ADDENDUM NO 1

CDC/320/25

Construction of Return Effluent Distribution Water Infrastructure to Zones 3, 5, 6, 7 and 9 of the Coega SEZ - Phase 1

Issue Date: 20 August 2025

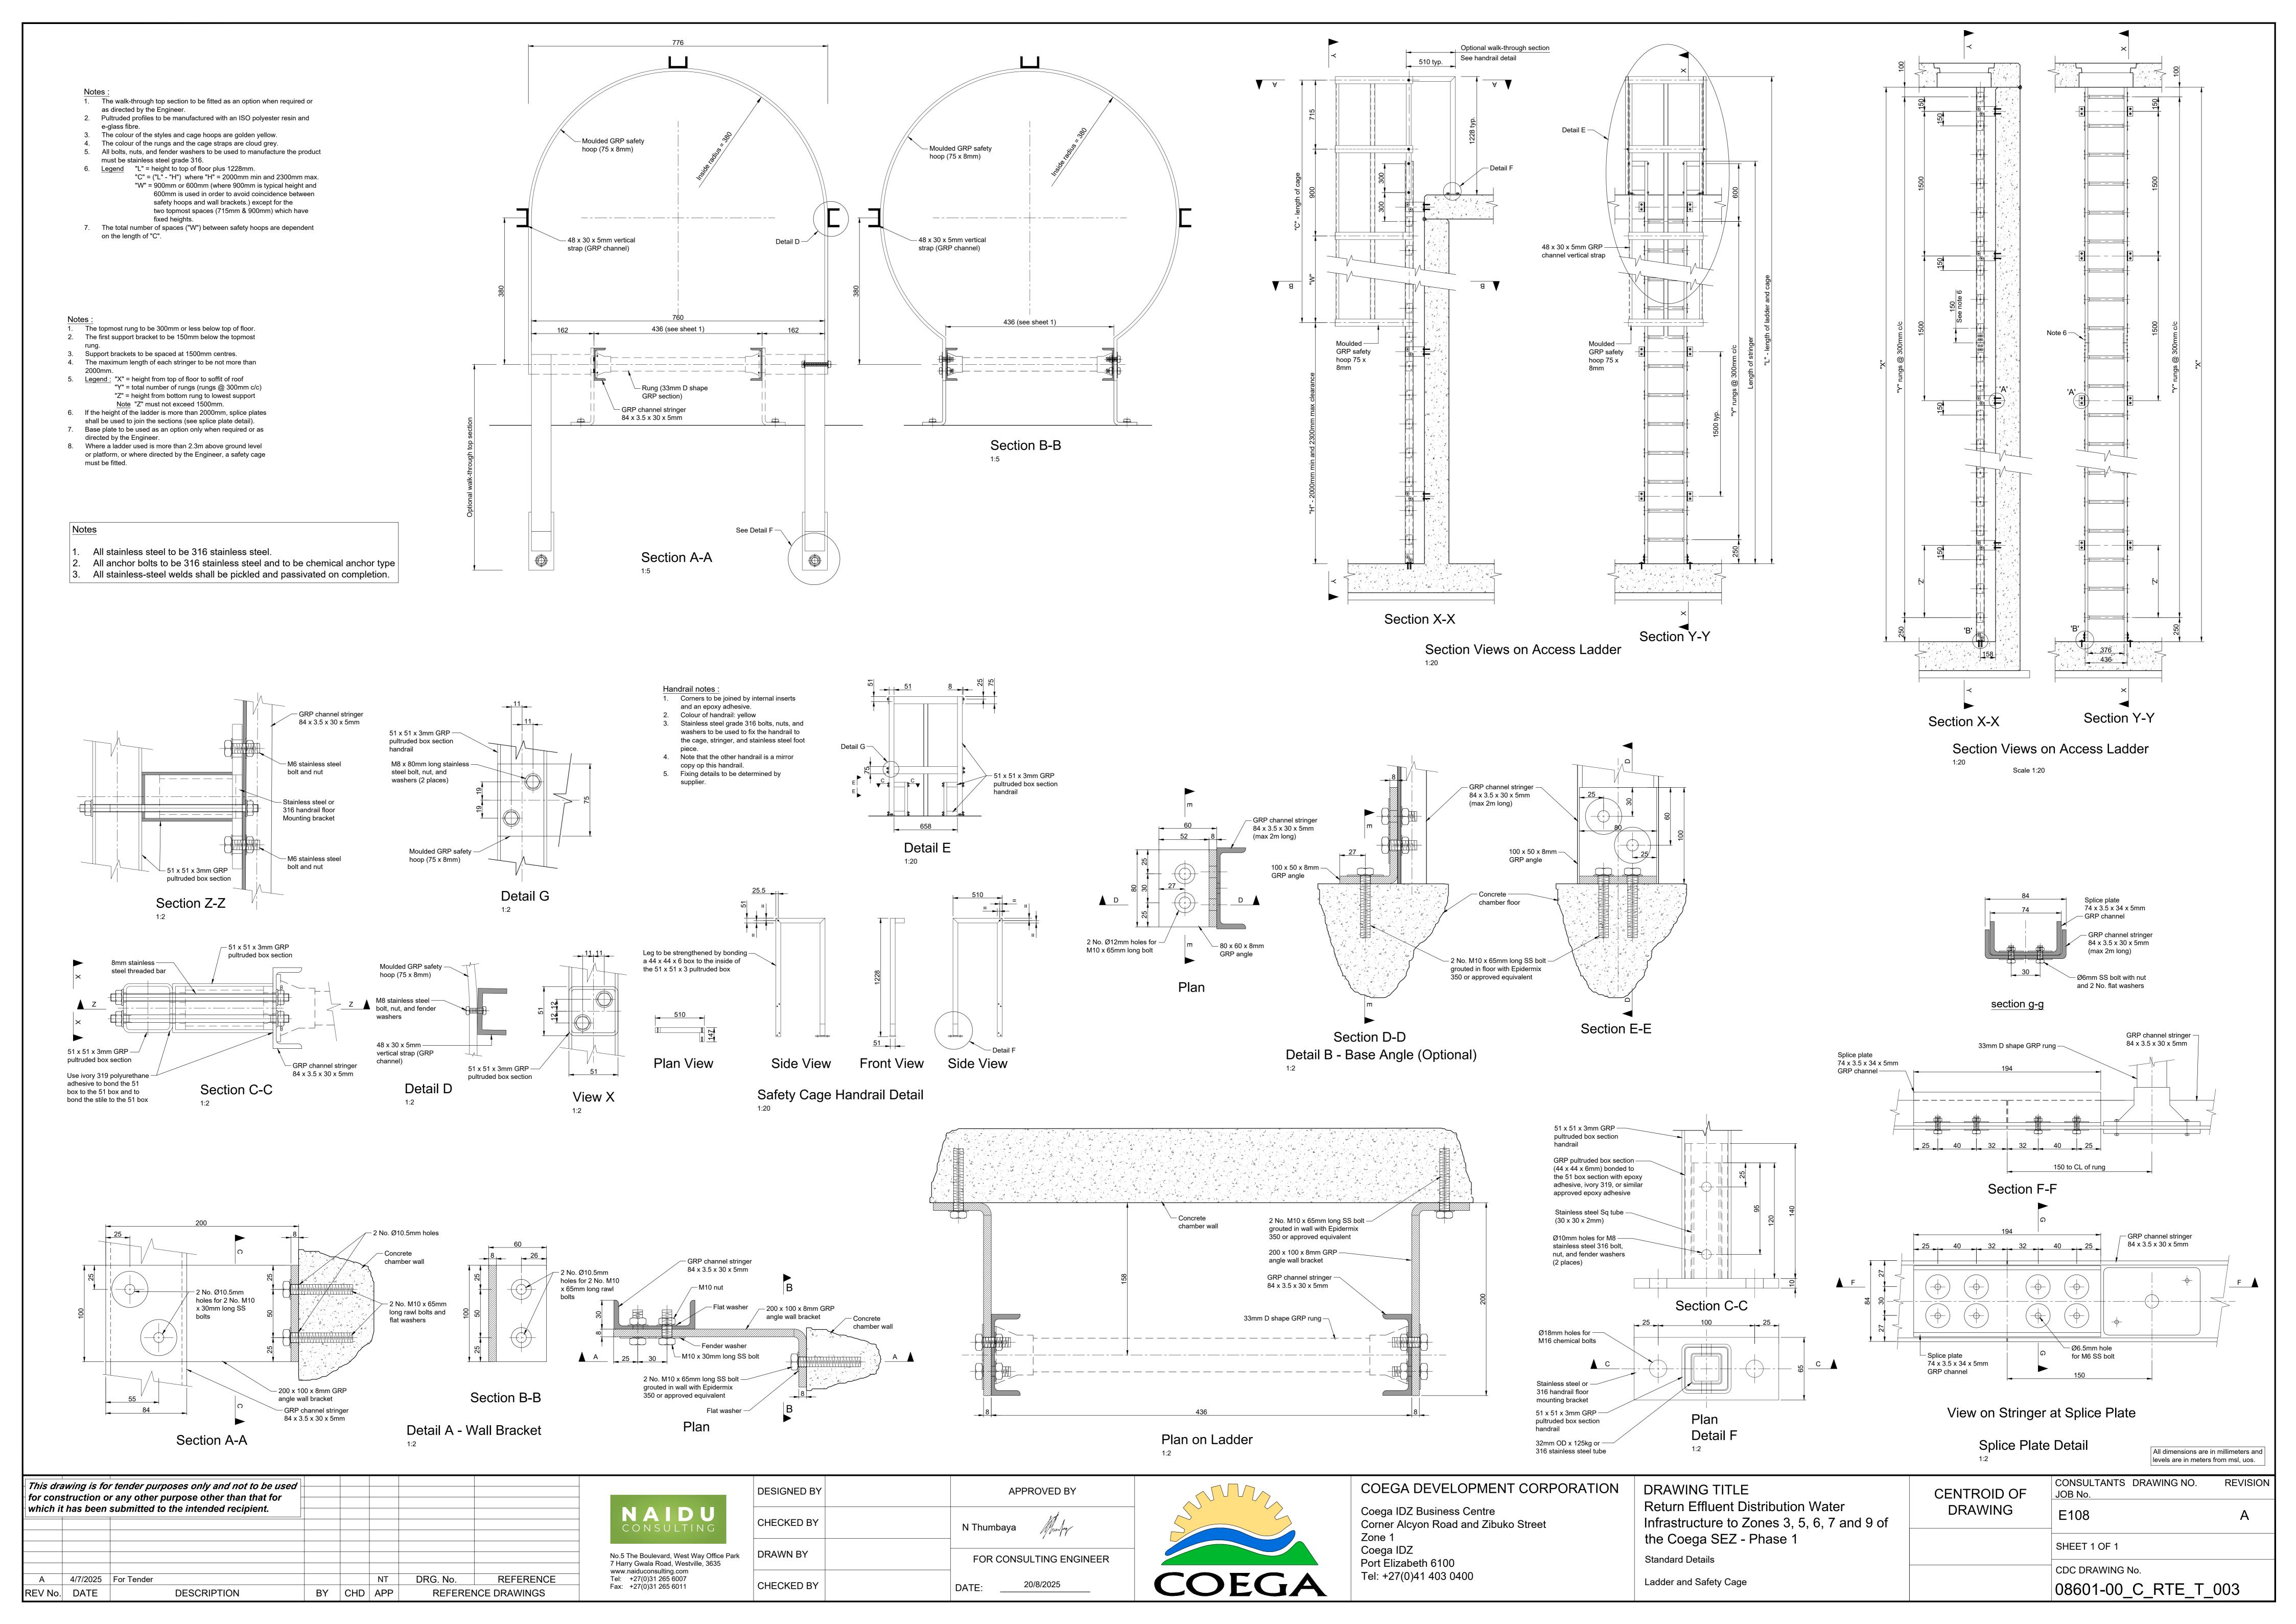
Add drawing 08601-00_C_RTE_T_003 to the tender drawing pack for ladder and safety cage standard details.

The tender document was issued with a tender drawing pack in C5.1 Annexure A that was meant to have consisted of the drawings listed on page 8 of Book 2. However, the PDF for drawing 08601-00_C_RTE_T_003 was not included and is now issued with this addendum.
